APPENDIX H

Requests for Information

Project Name:	Permanent Crossing Plan Round CSP Culverts	Project #	Tote Road Culvert Remediation
RFI #	1	Contract #	
Originator:	Michael Burns	RFI Submitted On:	March 6, 2024
Prepared By:	Michael Burns	Requested Response By:	March 7, 2024
Submitted To:	Greg Johnstone	Company:	Knight Piesold

Date:	March 8, 2024	File No.:	NB102-00181/93-A.01
		Cont. No.:	NB24-00286
To:	Michael Burns, Rudolf Dietrich		
Copy To:	Dale Tulloch, Jim Patterson, Sharon Dyke, BIM Document Control		
From:	Greg Johnstone		
Re:	Permanent Crossing Plan - Round CSP Culverts, Response to Baffinland Request for Information (RFI) No. 1

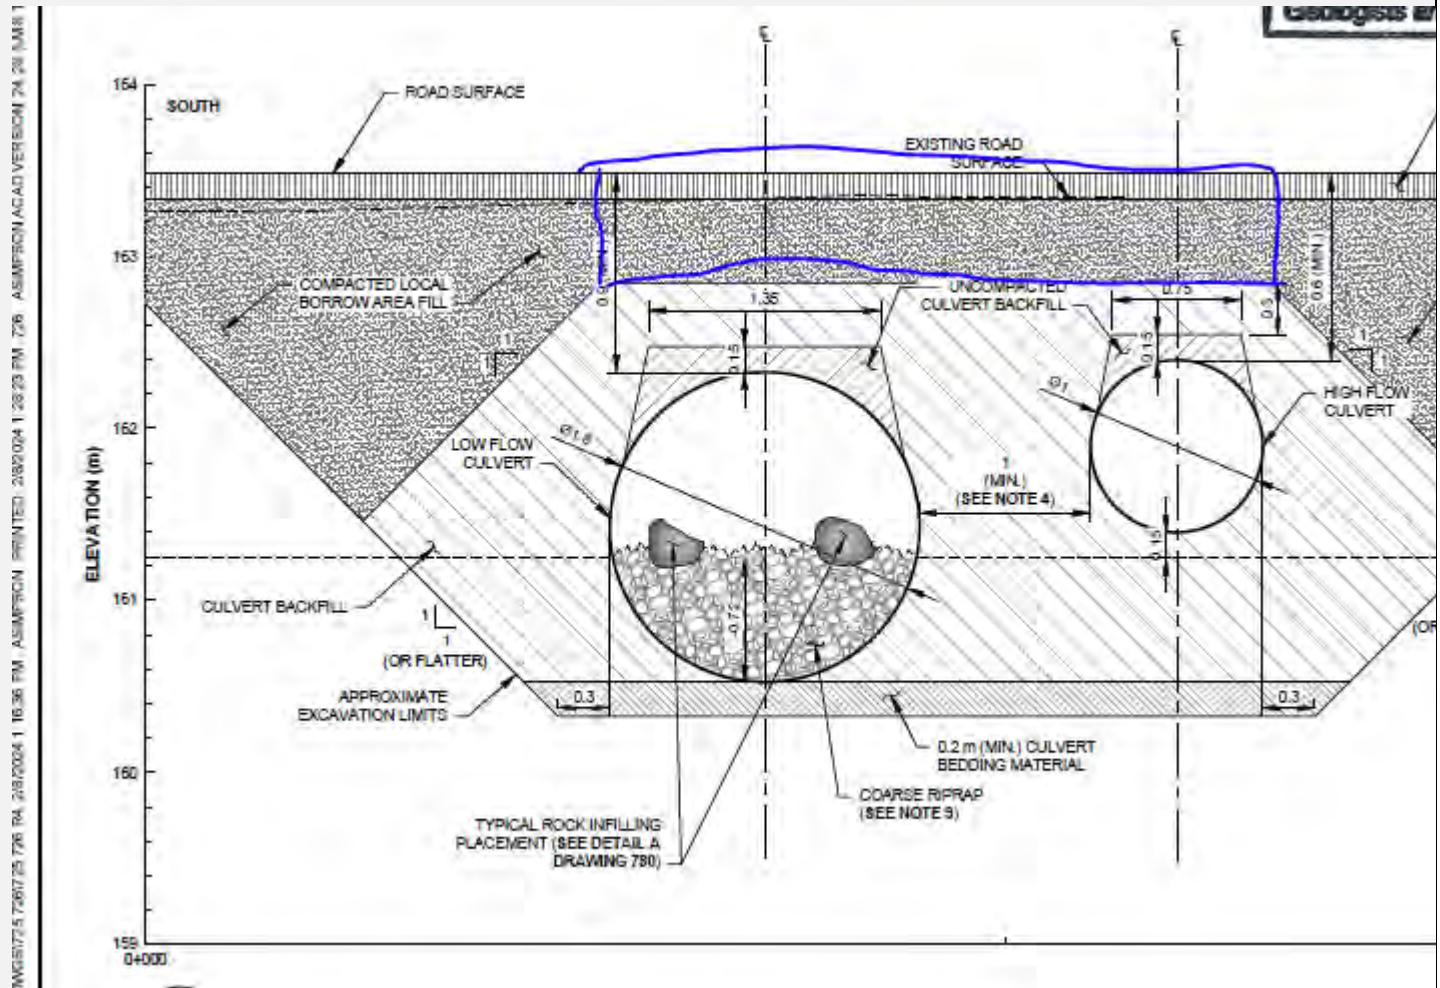
4. Addendum to original discussion is an email sent by Knight Piesold and the concern was the upper horizontal horizon of 32mm Special. Knight Piesold email in ***bold italics below***

“Following our discussion today, we realized we misspoke regarding the fill directly above the culverts (screenshot below). The minimum cover above the culvert includes both the 32 mm minus material and the local borrow area fill. In order to ensure we meet the manufacturers specifications for the minimum culvert cover depth, we recommend using the 32 mm minus with additional fines for this area and not the blasted material. If you choose to use the blasted material in this area, it may settle and the fill above the culvert will be below the minimum cover depth.”

KP does not recommend the use of the frozen blasted road material for this purpose as this may lead to road settlement, subsequently impacting the culverts. KP notes that this is Baffinland's decision to use this material in this location and they are assuming any risks/consequences of this change. In the event that the material is not ice rich nor frost susceptible, and placed/compacted as proposed, the change is expected to have limited potential impact on the structural integrity of the culverts.

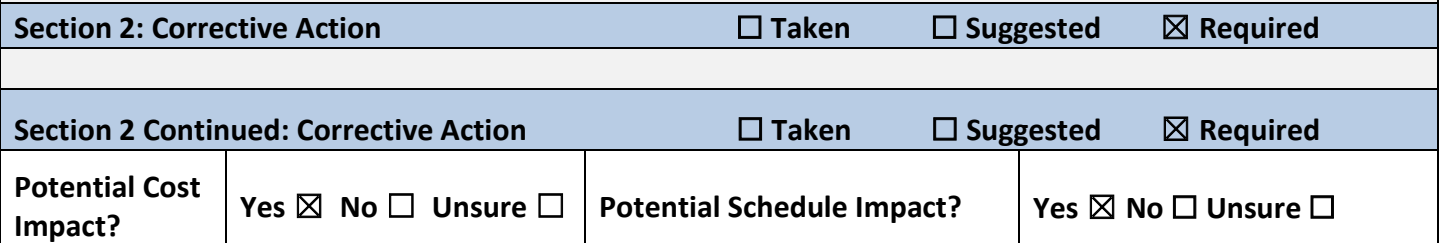
As per Zoom Meeting discussion today (March 13th, 2024) between site (Buck Wile, Dale Tulloch) and Knight-Piesold (Greg Johnstone) at the North Bay office, I would like to bring to your attention the following concerns with respect to culverts utilized as drop chutes in addition to water conveyance beneath the Tote Road (see Typical DWG741 attached).

BIM expresses reservations regarding KP's design, which suggests we incorporate 25-30% fine material as infill within the embedment riprap zone designed to go inside the culverts. This is particularly concerning for culverts designed to accommodate a significant drop in grade from the inlet to the outlet across the Tote Road. The embedment material specified for these culverts proposes a mixture utilizing frozen fine material, the specific type of which is yet to be determined. It is anticipated that this material will experience higher-than-normal velocities during seasonal freshet and rain events. These elevated velocities pose a risk of flushing fines placed between the coarse riprap layers, leading to degradation of the water surface profile above the rock surface. Such ongoing degradation of fines, could redirect water flow below the embedment rock surface and potentially impede fish passage through the culvert during low flows.

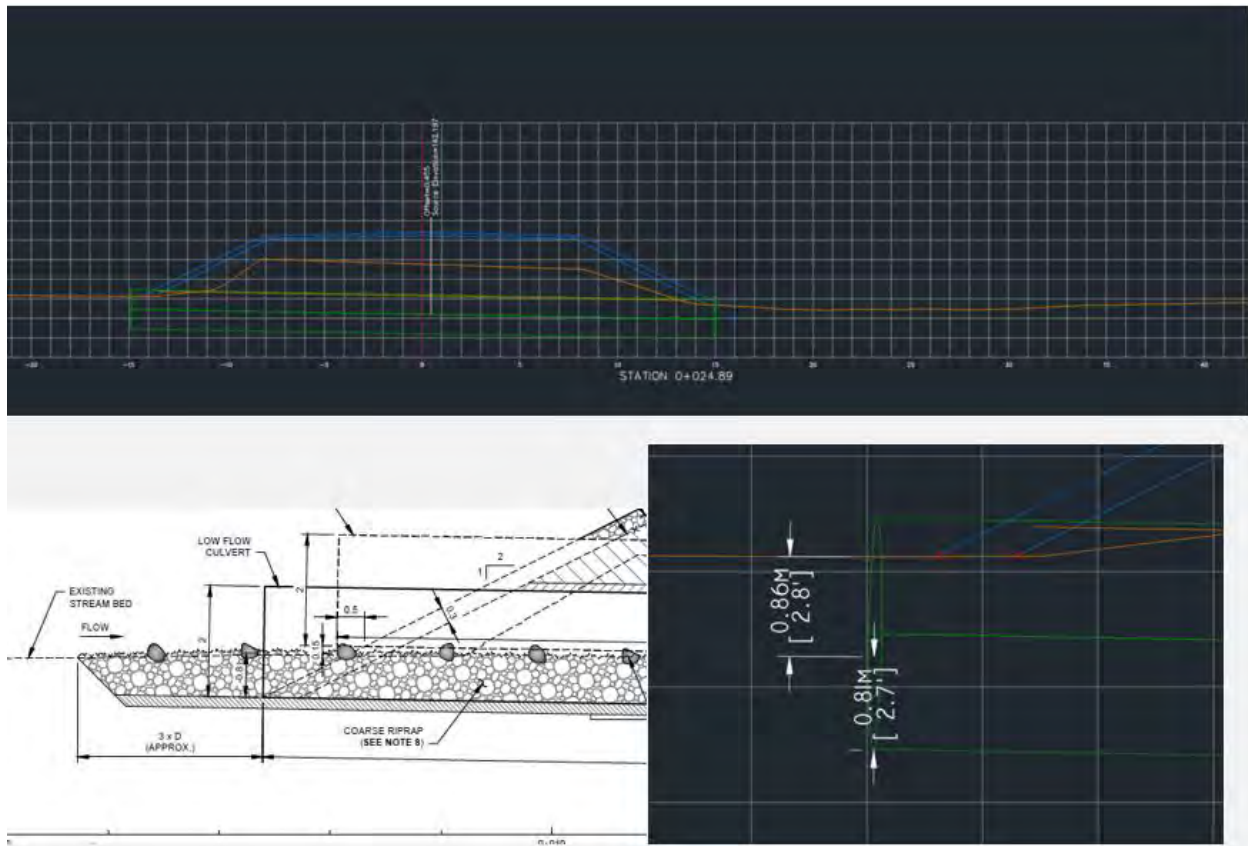
In the screenshots below, the orange line represents the existing ground elevation (Challenger, 2023). The green lines represent the 2.0m culvert (middle culvert).

Please provide revised invert elevations to allow for the culverts and installed streambed elevations to tie into existing elevations.

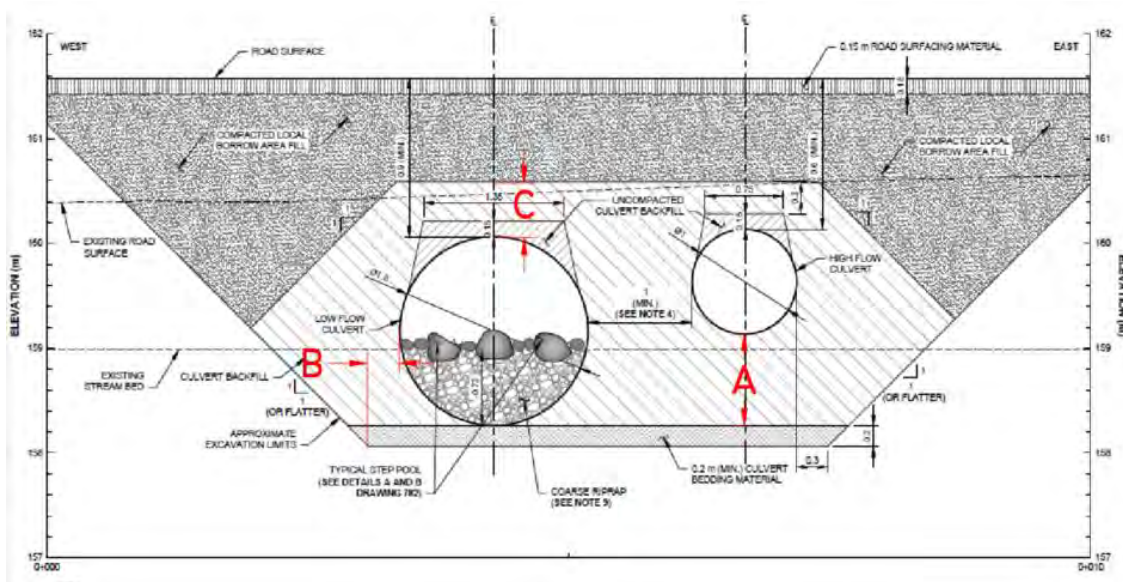
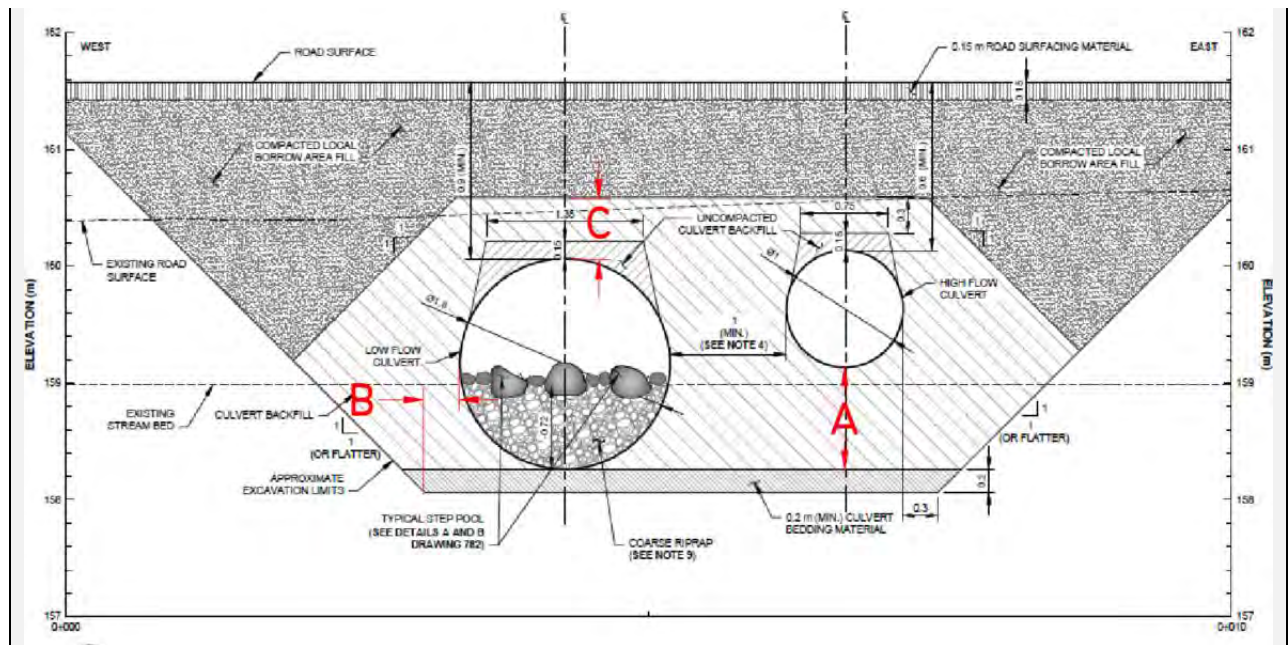
The section view on Drawing NB102-181/77 – 741 Is missing key data to allow Nuna to determine the elevation of the High Flow Culvert, Bedding material extents, and Culvert Backfill Material cover depth.

- Please provide Dimension A in the above screen shot. This will be used to confirm the invert elevation of the High Flow Culvert
- It is currently assumed that Dimension B is 0.30m. Please confirm.
- Please provide Dimension C. This will be used to determine the intended cover depth over the top of the Low Flow Culvert

- Dimension A: The measurement for A is 0.87 m (0.72 m + 0.15 m). The 0.15 m dimension between the low flow culvert material and the invert of the high flow culvert was inadvertently left off Drawing 741.
- Dimension B: Nuna's assumption is correct. The measurement for B is 0.3 m. This dimension was inadvertently left off Drawing 741.
- Dimension C: For this location, the measurement for C is 0.52 m (0.15 m + 0.37 m).

Figure 1 Example of design change shown on Drawing 706 R2 CV-114

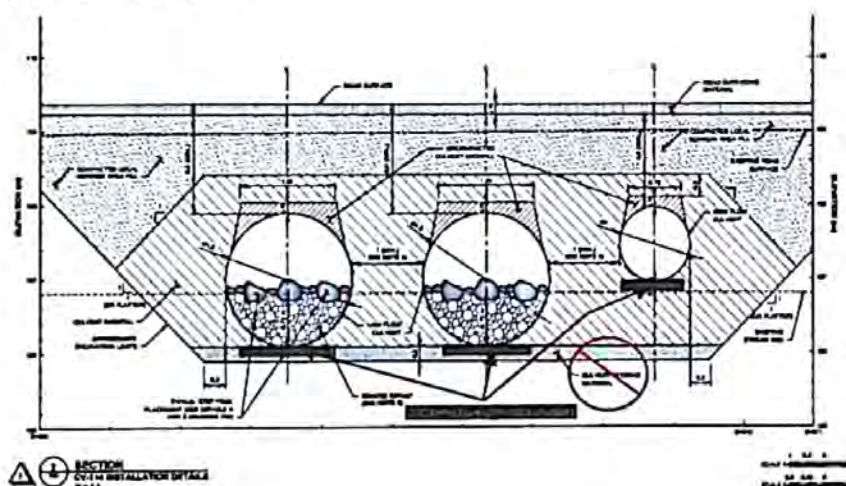
The purpose of the design change is to change part of the 25 mm minus bedding material (Fine Culvert Backfill) to a finer 3/16 inch minus material to meet the culvert manufacturer's recommendations. The design change will result in a 50 mm (2 inch) minimum thick, ½ culvert diameter wide, uncompacted zone of 3/16 inch minus crushed material being placed under the culvert(s) in place of the 25 mm minus material (See Figure 1). This design change will apply to all 10 round CSP culvert installations.

This change was requested by KP following receipt of recommendations from the culvert manufacturer (Armtec) to use a smaller size material that will fit between the round CSP culvert corrugations.

Figure 1 Example of Design Change Shown on Drawing No. 706 R2 CV-114

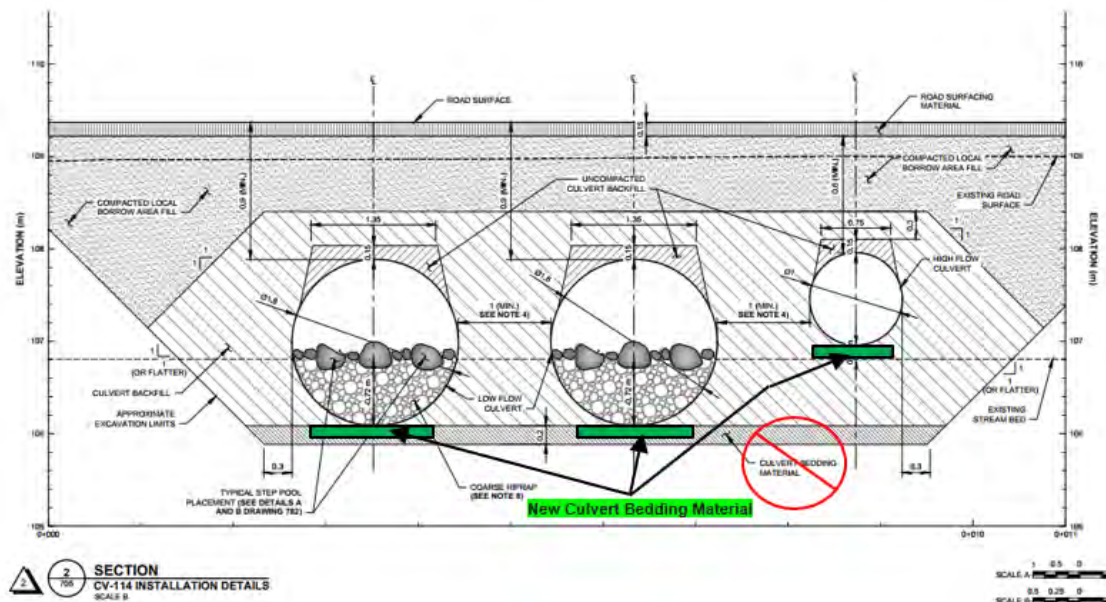
The details shown on Figure 1 of the scanned copy Nuna received are unclear.

Nuna also requires revised IFC drawings that clearly show the details of the change, so they can be modelled by our surveyors and laid out in the field.

As stated in Design Change 01, the 3/16" minus material will be placed in a minimum 50 mm (2") thick uncompacted lift. This material will be placed where the culvert has intimate contact with the foundation (approximately ½ the culvert diameter). Please see Figure 1 as an example.

Revised IFC drawings will not be provided for this design change. The surveyor can stake out the limits of the 3/16" minus material by offsetting from the culvert centreline.

1 SECTION
CV-106 PROFILE
SCALE A

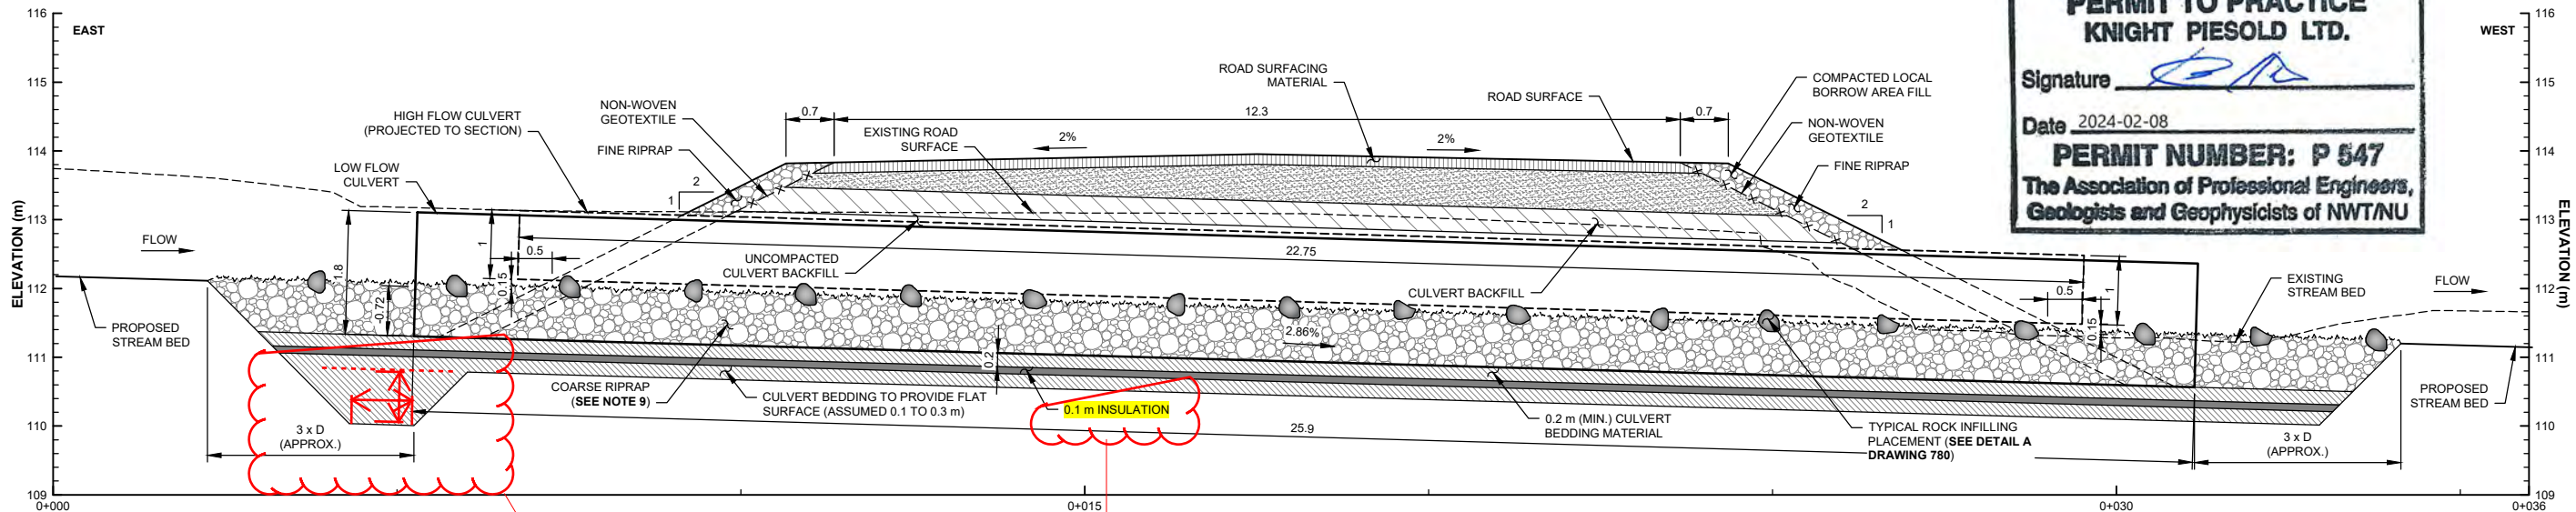
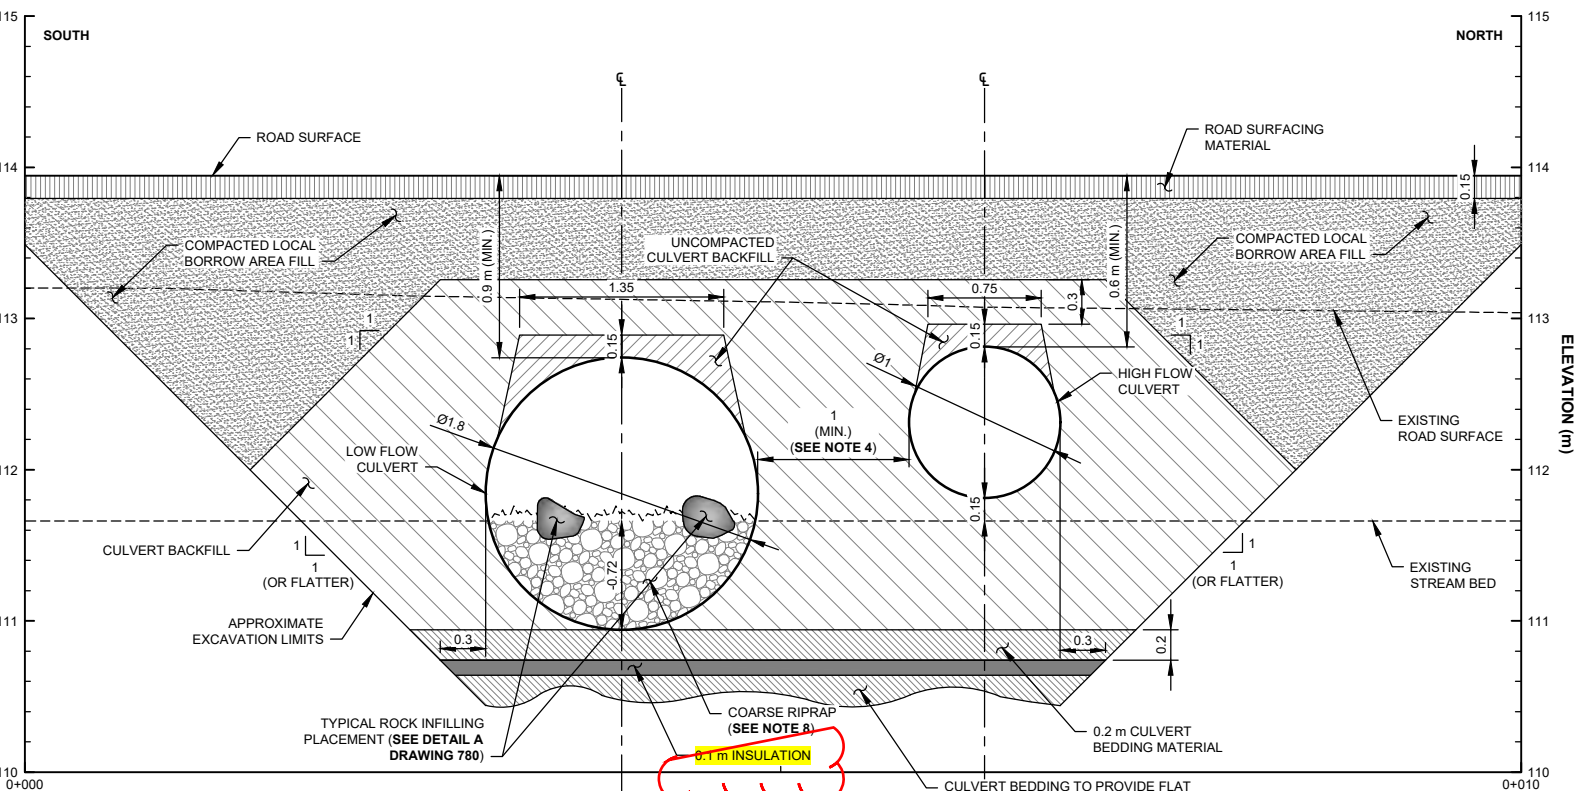
Missing dimensions

Missing specs
